ROYAL PINE HOMES – SITE INSTRUCTION

SITE INSTRUCTION NO.3.RP.INTERIORS			
PROJECT:	Hampton Place	LOCATION:	25 Baker Hill Blvd Stouffville, ON
DATE:	Dec 13, 2018	BY:	L. Renzetti

GUEST SUITE

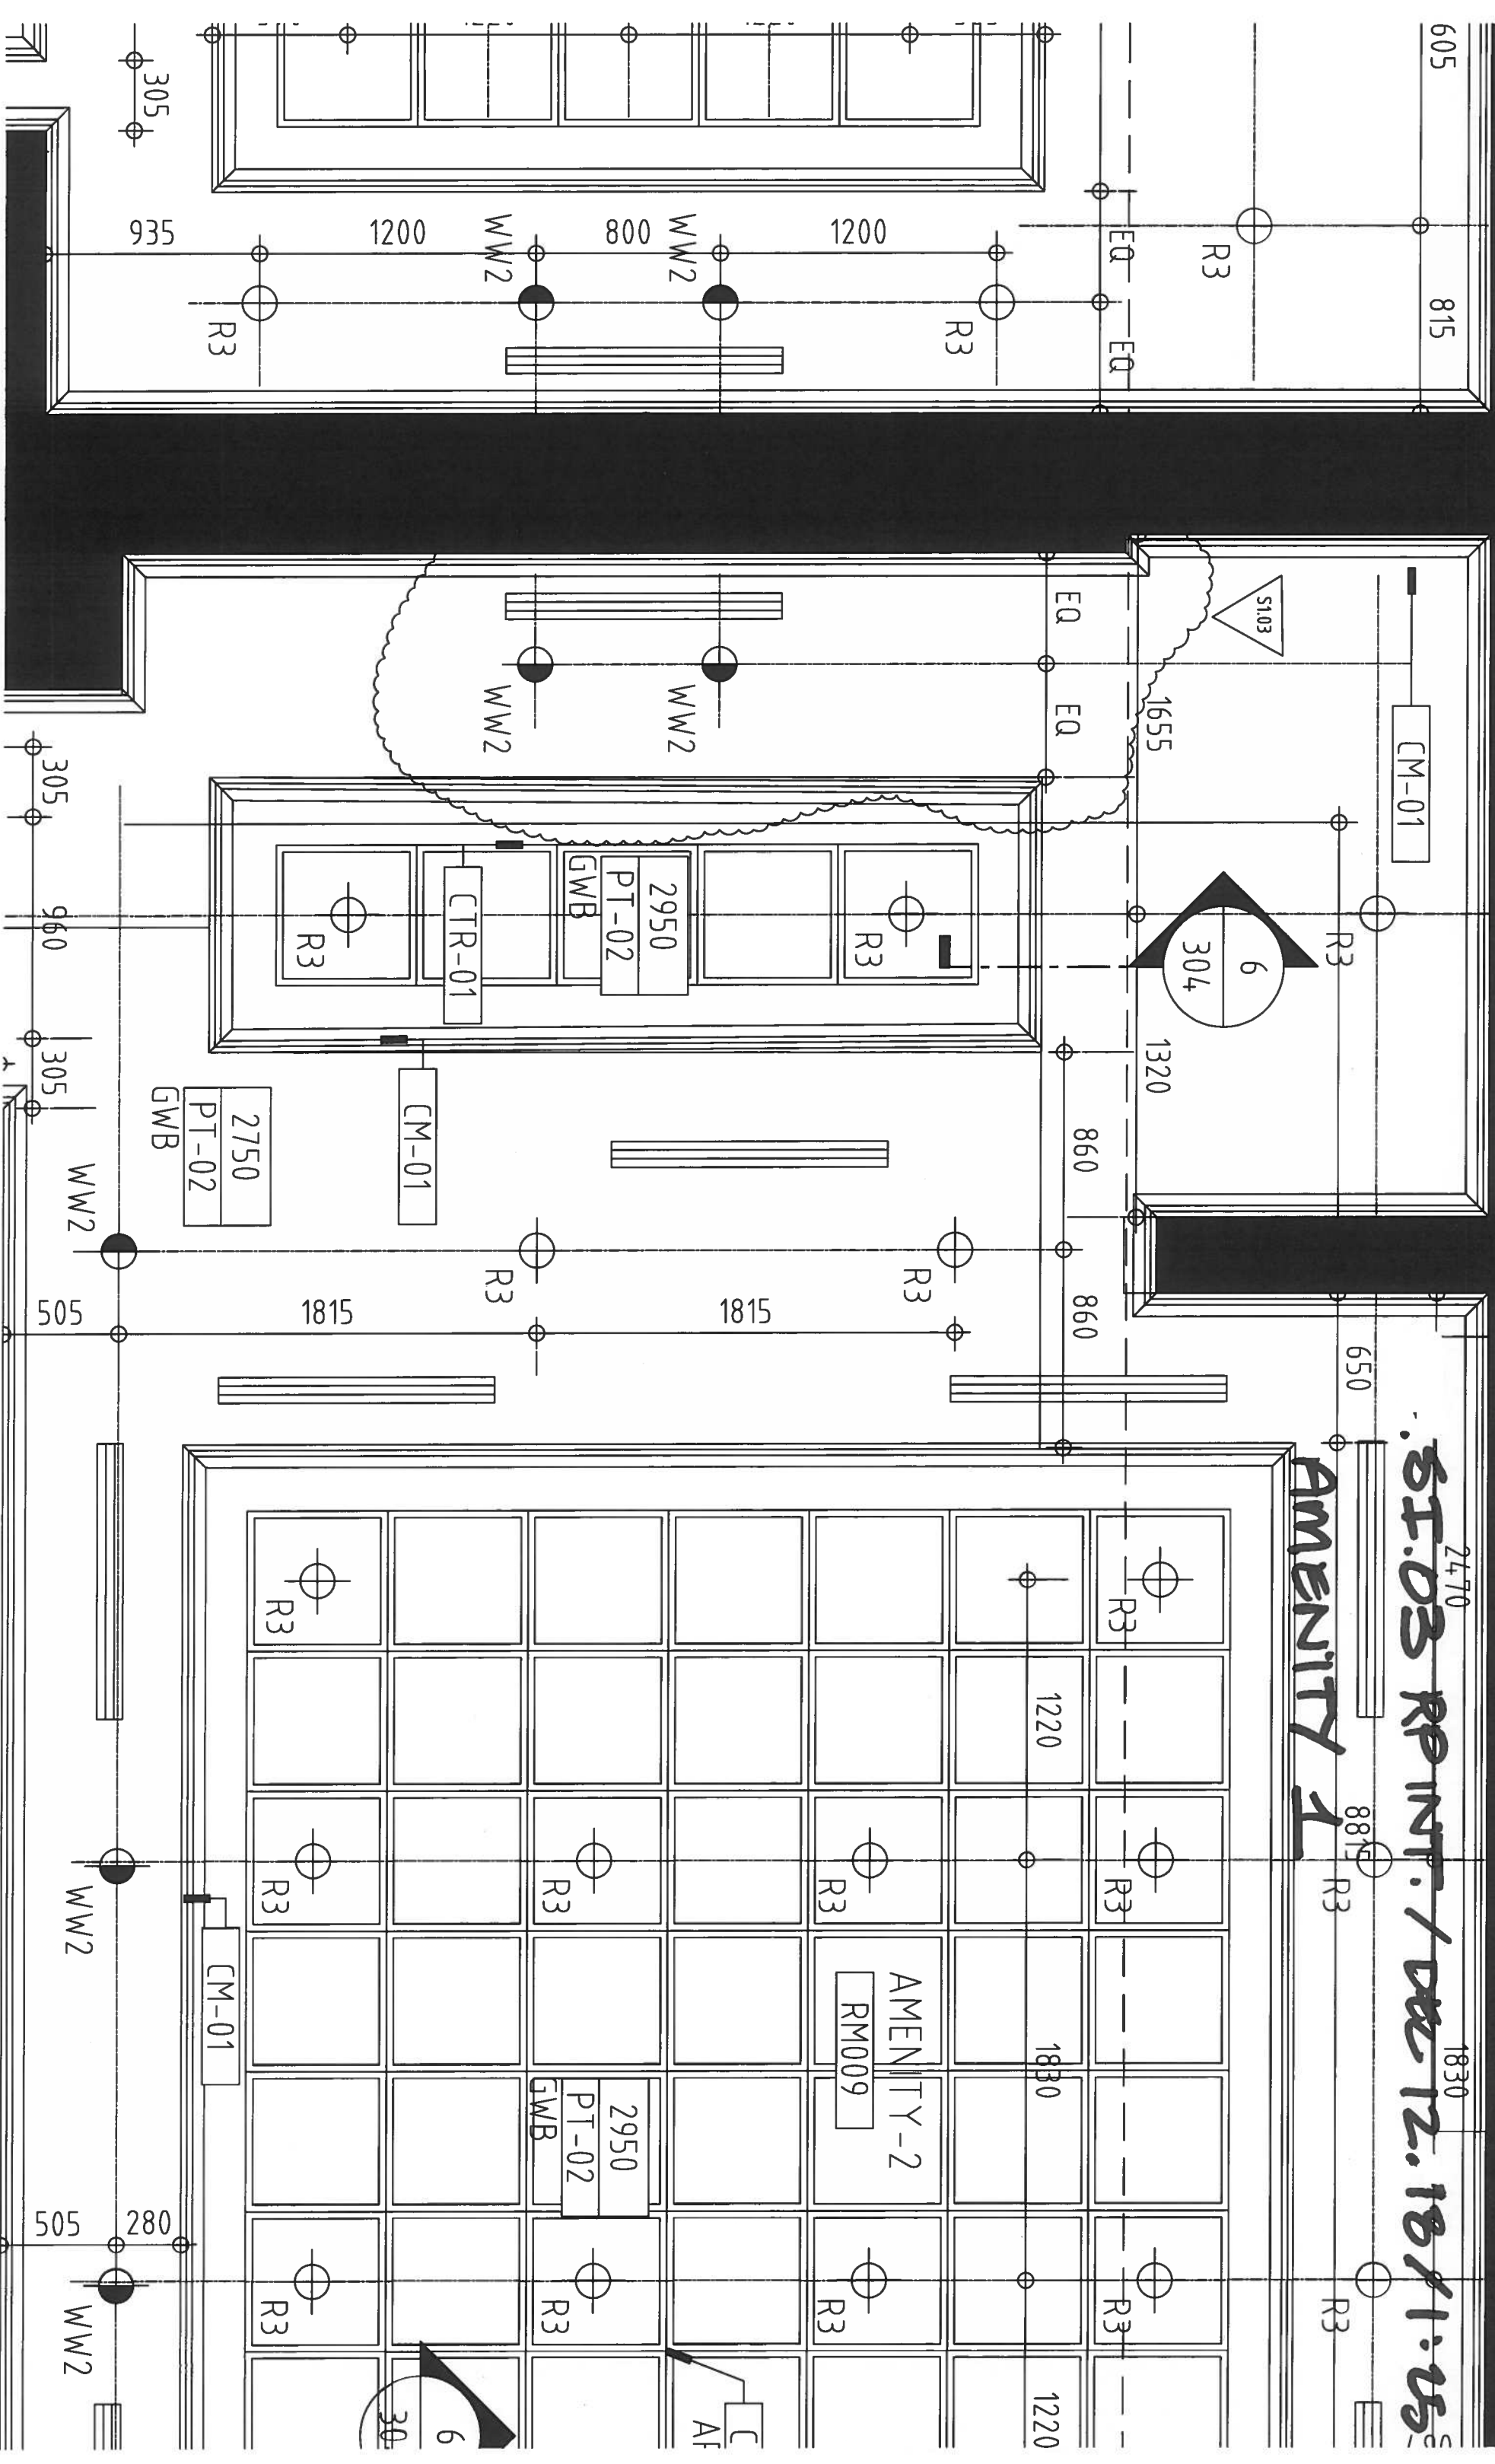
1.82	Guest Suite	CHANGE: Add cable television and outlet to accommodate cable and TV Refer to attached drawing
1.83	Fitness Rm	CHANGE: Fur out concrete wall to accommodate electrical components for wall hung televisions

ADD CABLE TV. (51.03)

1 ELEVATION
4.10 TYPICAL 2ND TO 6TH FLOOR CORRIDOR

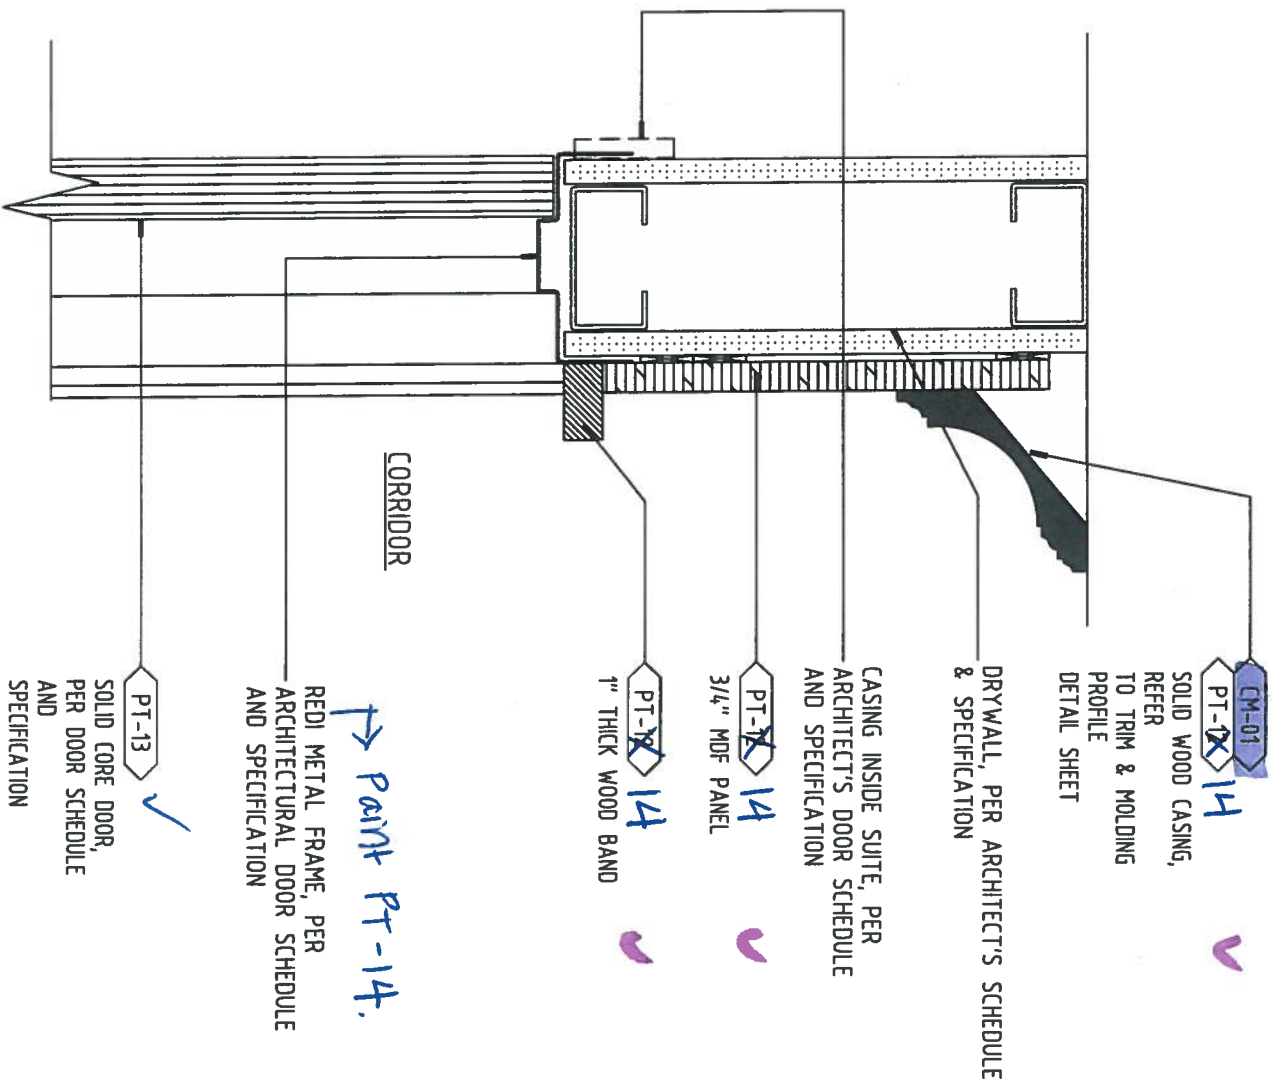
1.11	1/302 AND 1/410	CLARIFICATION: Ground floor corridors to suites, Walls and base as per floors 2 nd to 7 th , PT-11 for walls and B-01b for base (paint base PT-14)

4 TYPE **G** - DETAIL ELEVATION
102 FITNESS DOOR
SCALE: 1:15

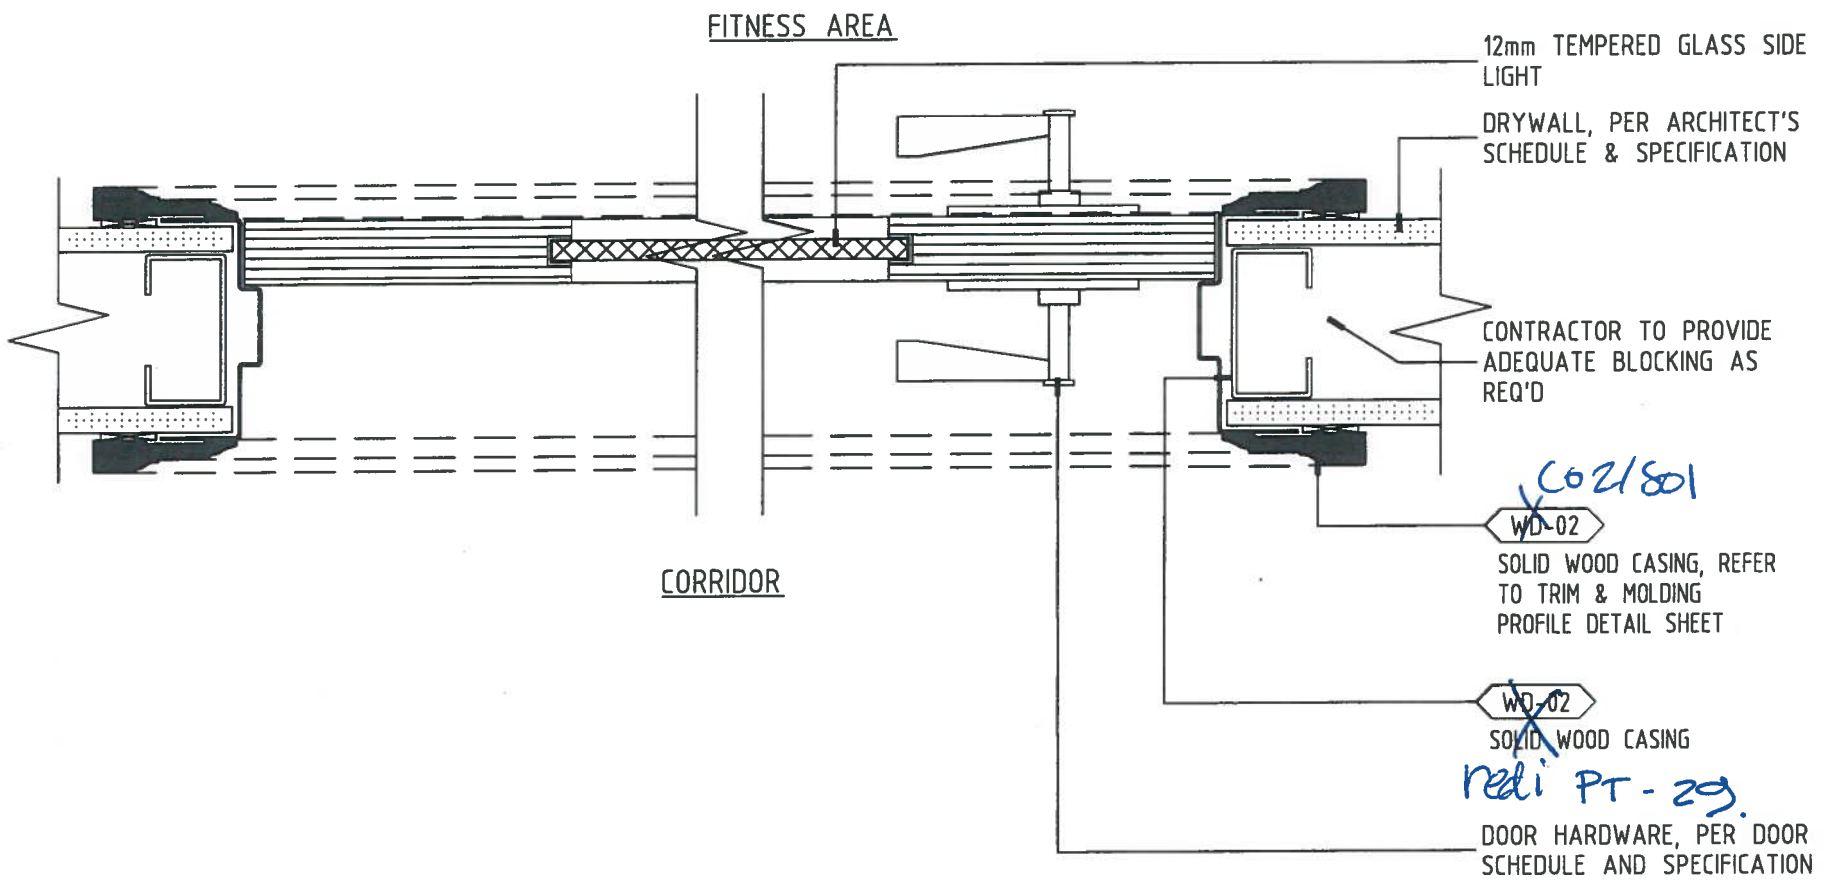
1.12	ID303	CLARIFICATION: Fitness Door g22, Plans indicate a sidelite adjacent to the door. There is no sidelite. Refer to attached elevations and door type.

1.13	Architectural Door schedule, Door at Fitness g22	CLARIFICATION: Door type a not b. Refer to INON drawings and schedule.
1.14	Transition 3/305	SITE COORDINATION: Sports flooring to tile – sports flooring 6.4 mm thick. Schluter 1.2 Reno to be replaced. Flooring contractor to provide alternative to RP for approval.

Paint redi
Pt-29. ✓

5
102

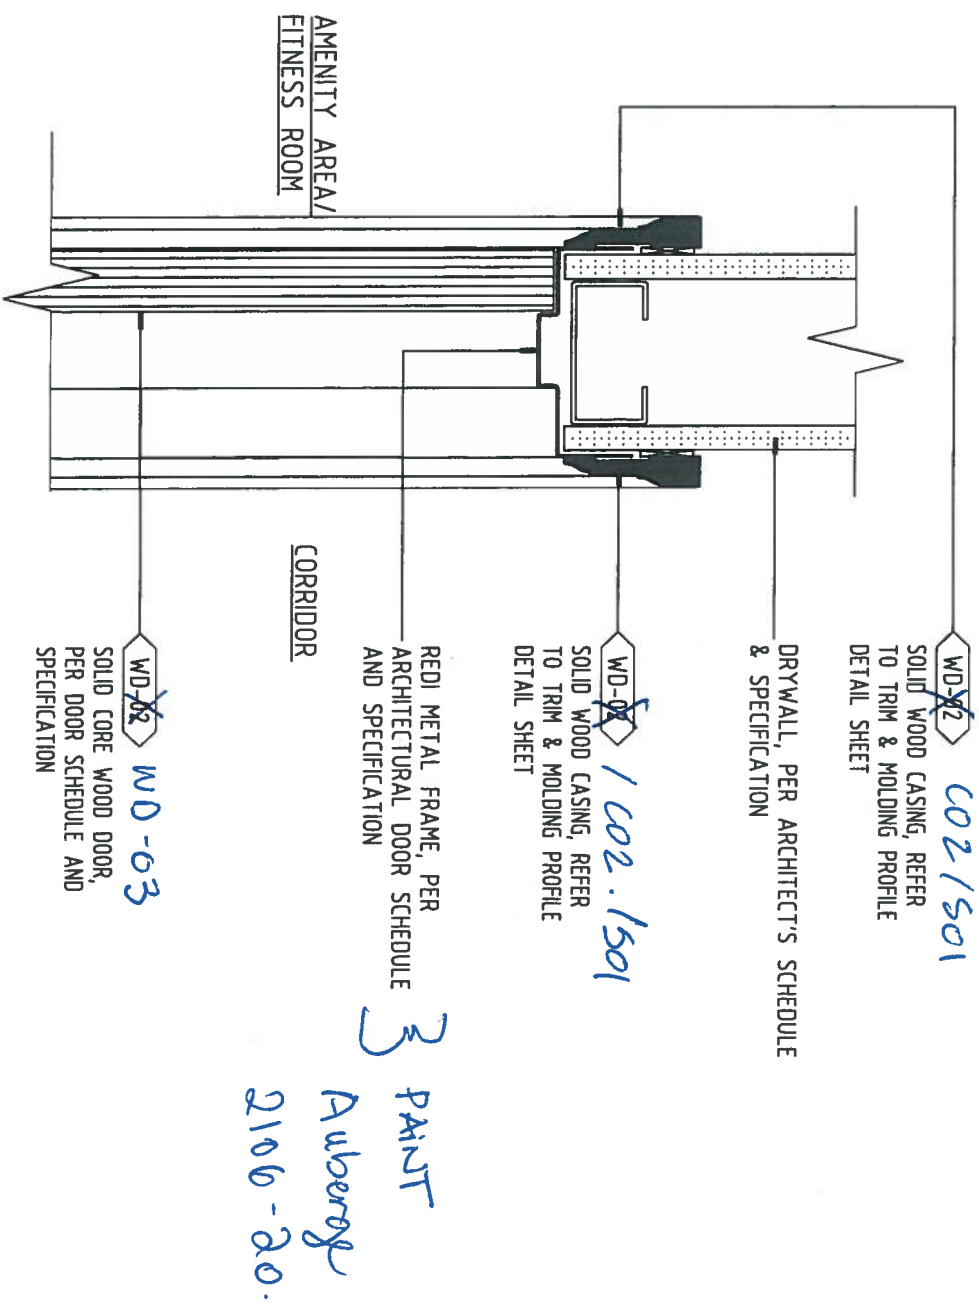
1.06	Suite Entry Door Hardware Spec	CLARIFICATION: Morgan, Signature Series, Boston, Satin Nickel. Supplied by Citiwide, installed by Penegal
1.07	5/305 Section at Suite Entry Threshold	CLARIFICATION: to note "solid wood threshold stain the match engineered hardwood flooring" to read "solid wood red oak stain to match door trim PT-14 Pewter 2121-30 Eggshell, submit 3 samples for RP approval". Urethane Finish
